## Field Observation Report #02

Project Title Fox Theater Roof Rehabilitation Project Address 715 Main Street Architect Project # 23-029 Observed By: Natalie Lord

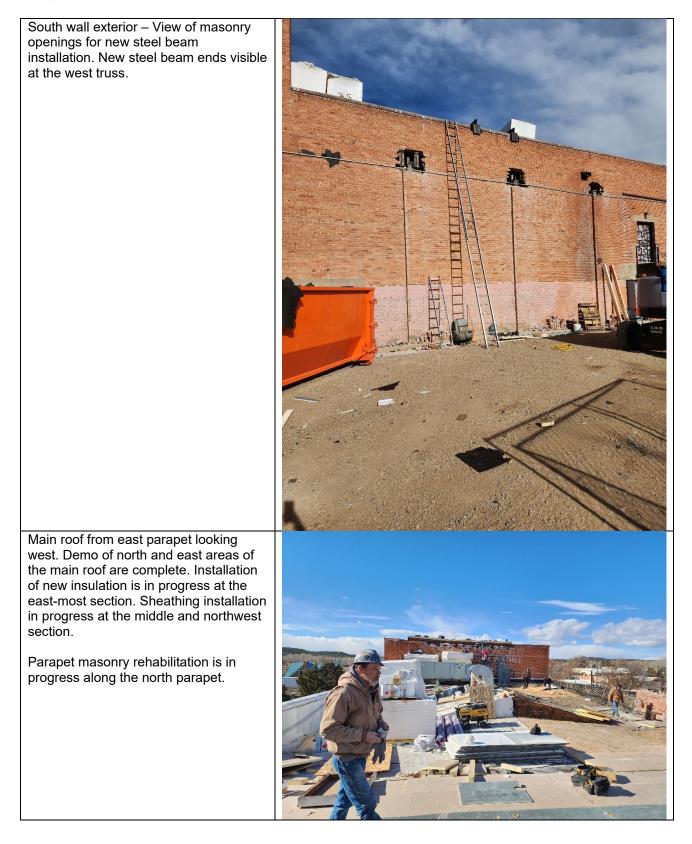
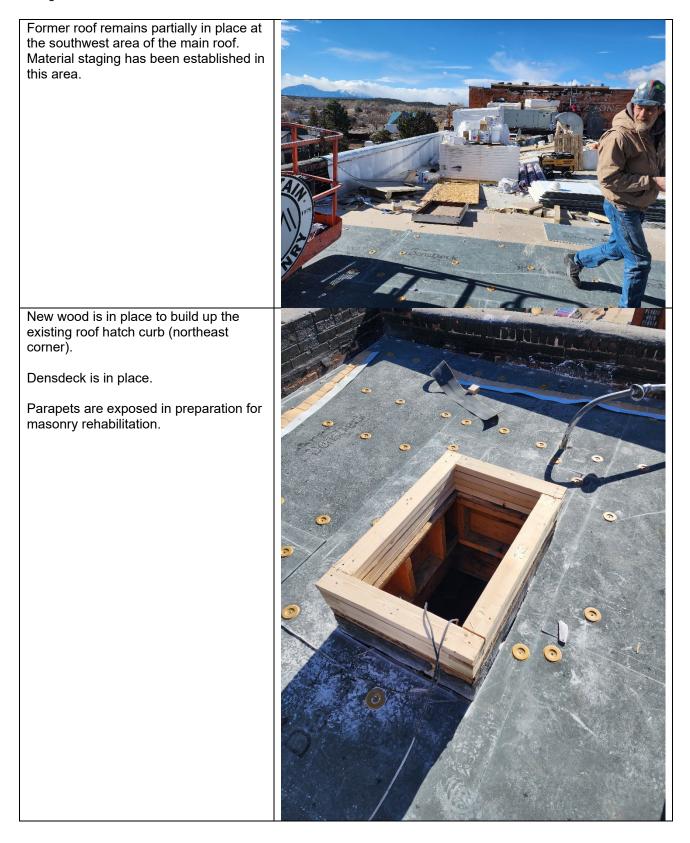
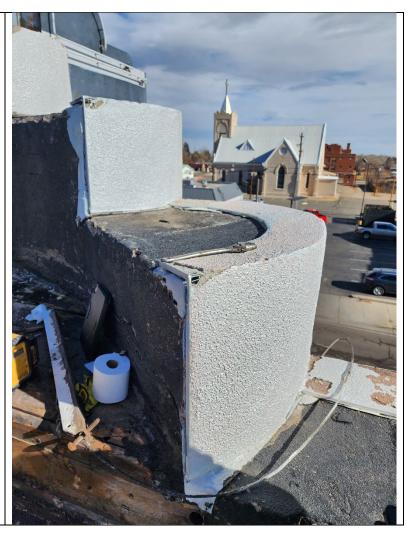
Southern portion of east parapet. Edge of marquee visible at left.	
Densdeck is in place. Existing pipe penetration remains in place.	
Parapets are exposed. Contractor removed the stucco from the top face of the parapet along this section to review conditions with Architect and History Colorado and discuss details at roof to stucco transitions.	
	0 3C/5 0 1080 0
View of northeast corner of the main roof.	
Masonry rehabilitation of parapets is in progress in this area.

Architect, Contractor and History Colorado discussed options for the termination of roofing and flashing at the existing marquee and parapets where stucco wraps up and over the sky facing areas (east parapet with corners wrapped at north and south). Several options were brainstormed.

Contractor and his roofing subcontractor will review the options discussed and come back to the Team with a proposed detail.

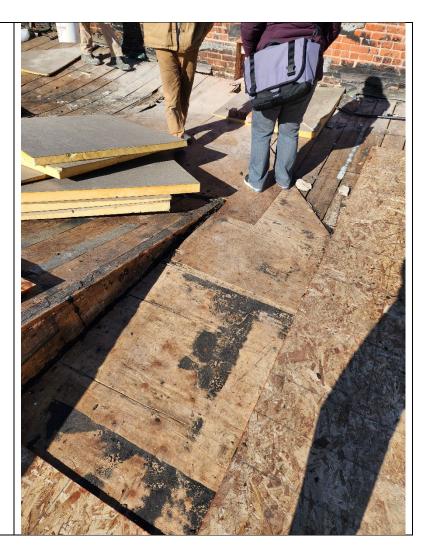
North scupper roof drain – Contractor has enlarged the roof scupper opening at the interior wythes of the brick wall for review (former scupper opening is visible in outer wythe). The opening will allow for better drainage, since clogging and flooding at the former drains has occurred several times at the building.

Note: collector box sizing and downspout sizing will need to be confirmed by manufacturer based on new scupper size.

Architect and History Colorado approved new opening.

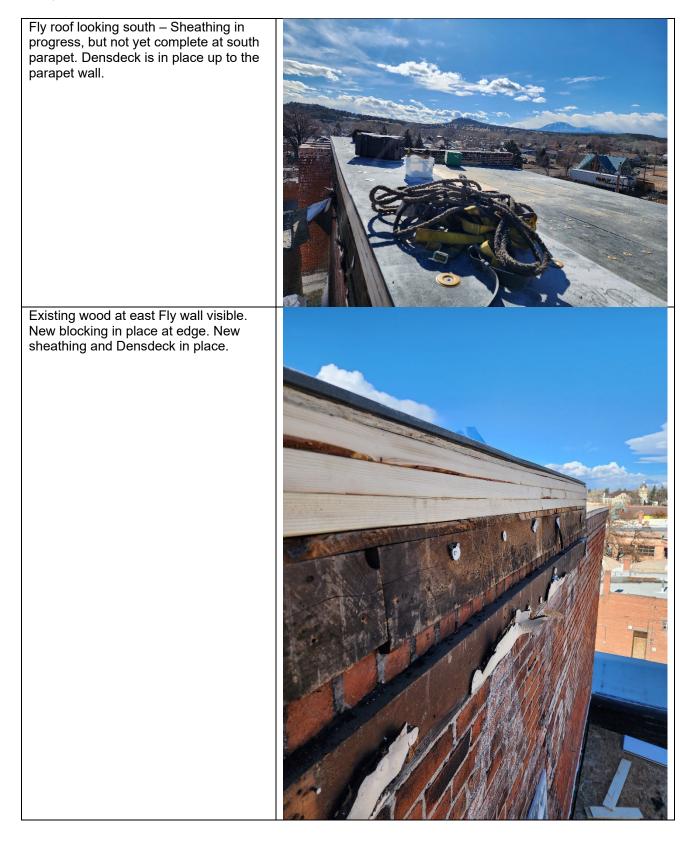
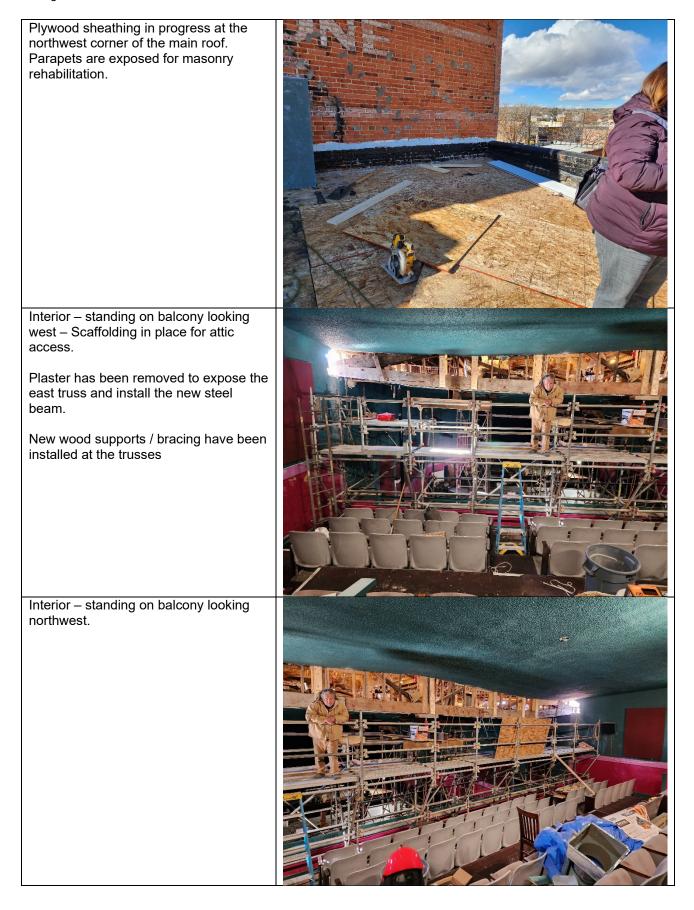
Architect, Contractor and History Colorado discussed potential location of new roof hatch. Contractor is proposing to locate the new roof hatch roughly in the red outlined area. This location appears to work with the former ductwork layout in the attic below.

Note: new mechanical design is not included in this project and will be part of a future building project. Therefore, coordination with future mechanical design is not achievable.

Owner to review and confirm location.
